Millstone Power Station, Unit No. 1  
Licensing Basis Document Change Request (LBD CR) 01-03-2  
Fuel Storage Requirements, Technical Specification 4.2

**Licensing Basis Document Change Request (LBDCR) 01-03-2  
Fuel Storage Requirements  
Evaluation of Proposed Changes and Safety Summary**

**PROPOSED TECHNICAL SPECIFICATION CHANGES (MARK-UP)**

FIGURE 4.1  
MILLSTONE UNIT NO. 1 SPENT FUEL POOL

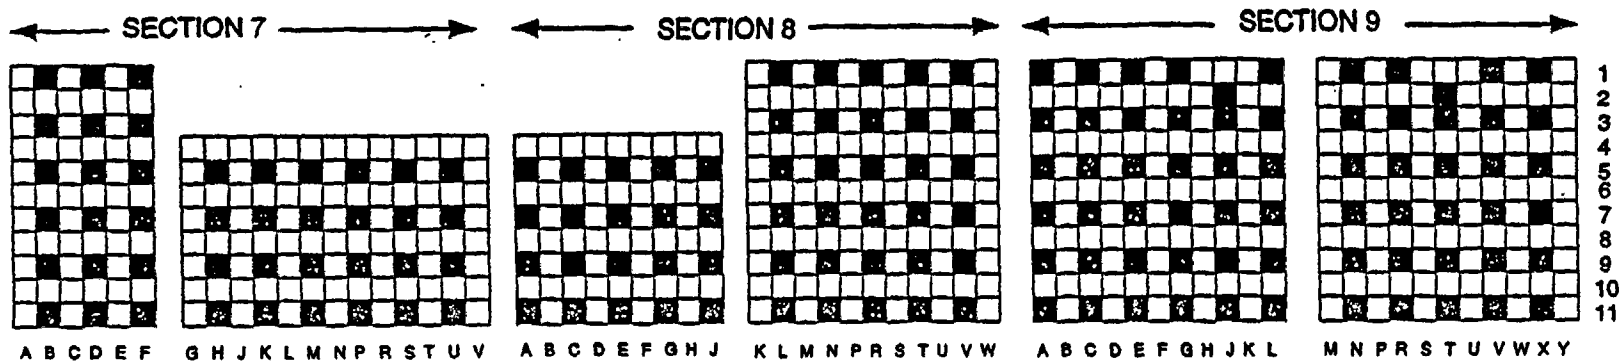
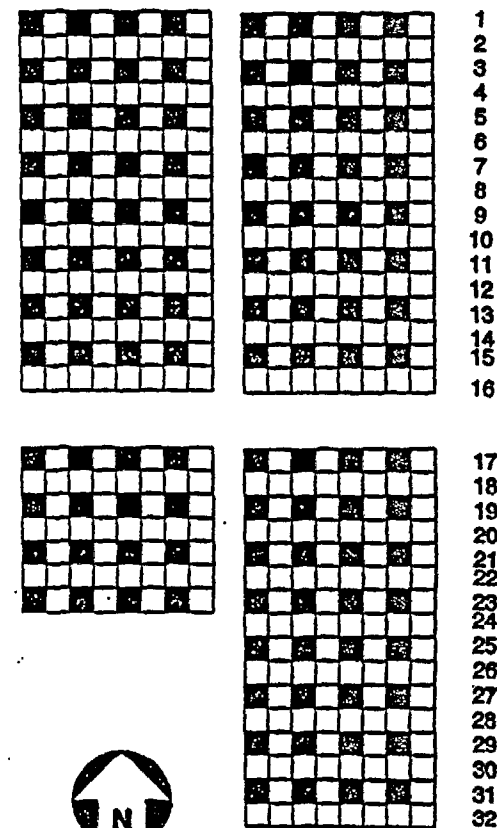
4.2.2 The  $K_{eff}$  of the spent fuel storage pool shall be less than or equal to 0.95 ← 0.90. This  $K_{eff}$  value is satisfied with fuel assemblies having a maximum k-infinity of 1.24 in the normal reactor configuration at cold conditions, and an average U-235 enrichment of 3.8 weight percent or less, and with no fuel allowed in the storage locations shown in Figure 4.1.

Add this page

FIGURE 4.1  
MILLSTONE UNIT NO. 1 SPENT FUEL POOL

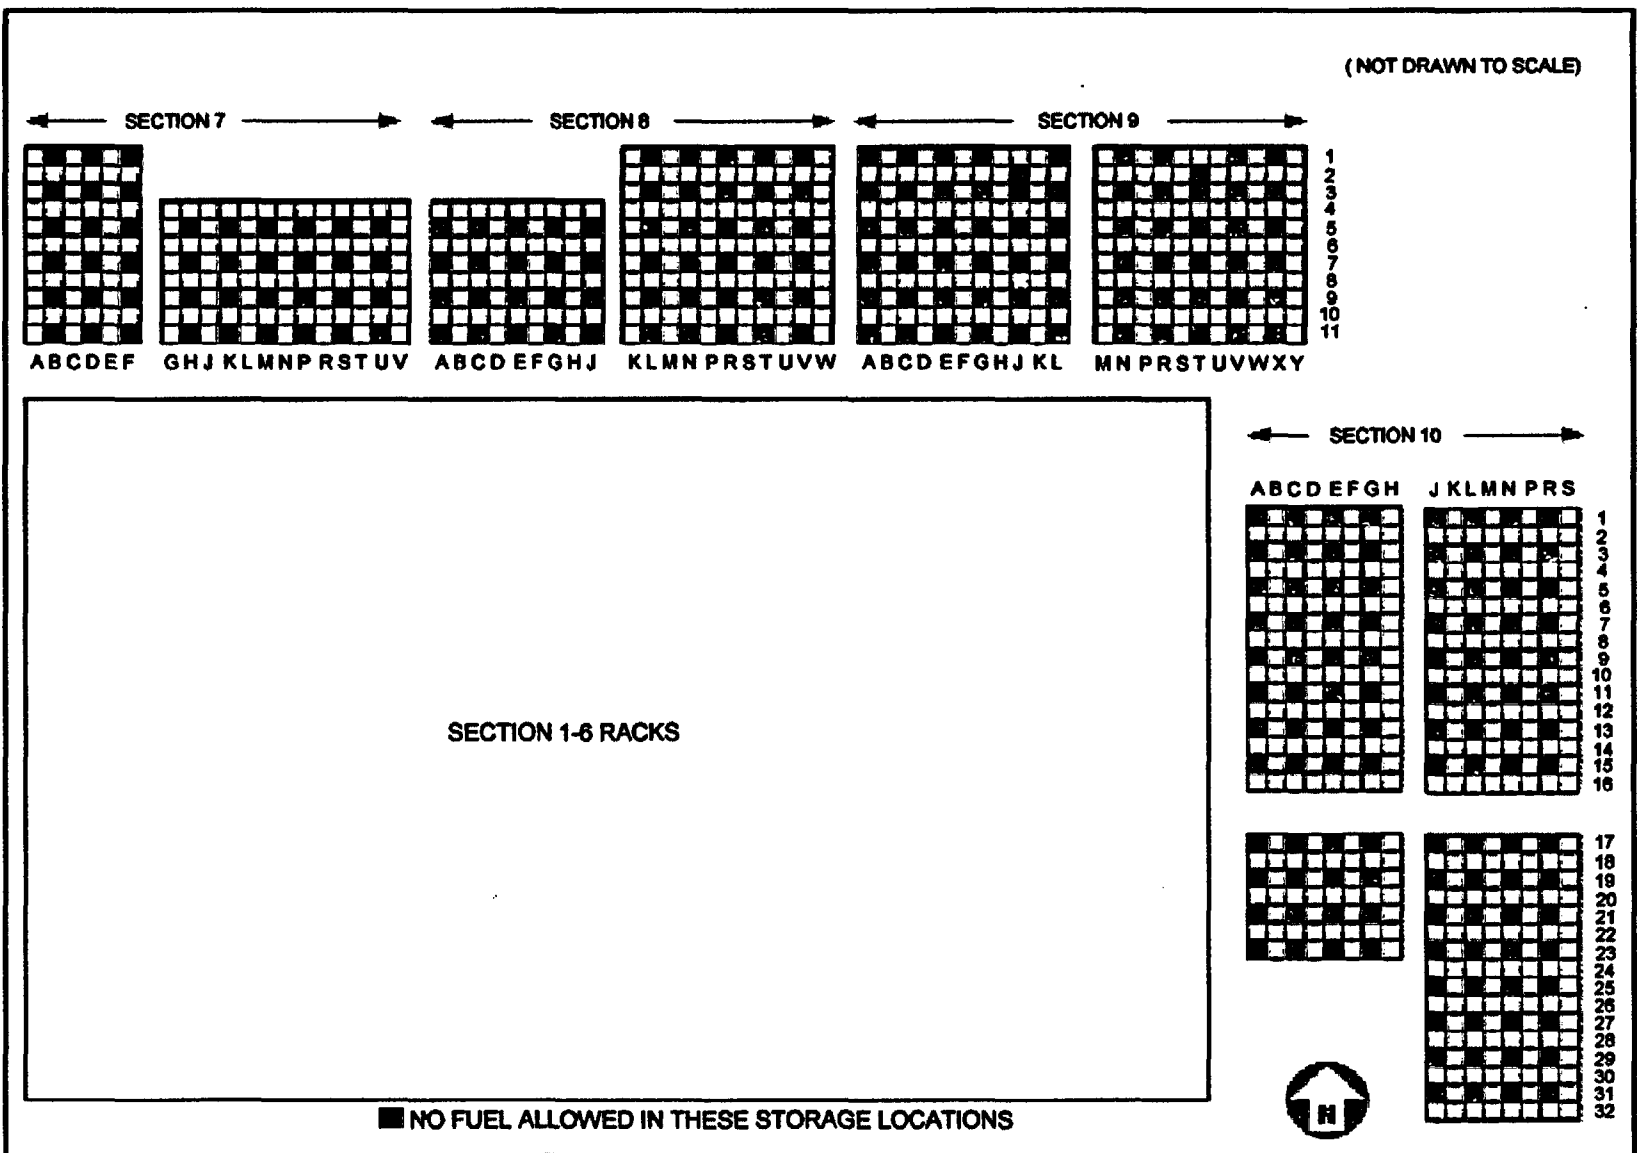
**4.2.2** The  $K_{\text{eff}}$  of the spent fuel storage pool shall be less than or equal to 0.95. This  $K_{\text{eff}}$  value is satisfied with fuel assemblies having a maximum k-infinity of 1.24 in the normal reactor configuration at cold conditions, and an average U-235 enrichment of 3.8 weight percent or less, and with no fuel allowed in the storage locations shown in Figure 4.1.

Proposed Technical Specification Figure 4.1 shows the required 3-out-of-4 fuel storage pattern to ensure that the criticality analysis remains valid. As shown in Figure 4.1, spent fuel pool locations 9-1-J and 9-1-T allow fuel storage, and spent fuel pool locations 9-2-J and 9-2-T do not allow fuel storage. These locations do not have the repeating 3-out-of-4 pattern that is evident in the other Boraflex rack locations. This was necessary to avoid moving the 2 fuel assemblies from spent fuel pool locations 9-1-J and 9-1-T. It is difficult to move fuel from these 2 locations due to wall interferences. As a result, it was verified by additional KENOva calculations that spent fuel pool locations 9-2-J and 9-2-T are adequate substitutes as "non-fuel" locations, instead of spent fuel pool locations 9-1-J and 9-1-T. KENOva calculations performed by Dominion Nuclear Connecticut, Inc. (DNC) confirmed that there was no adverse effect due to this change.
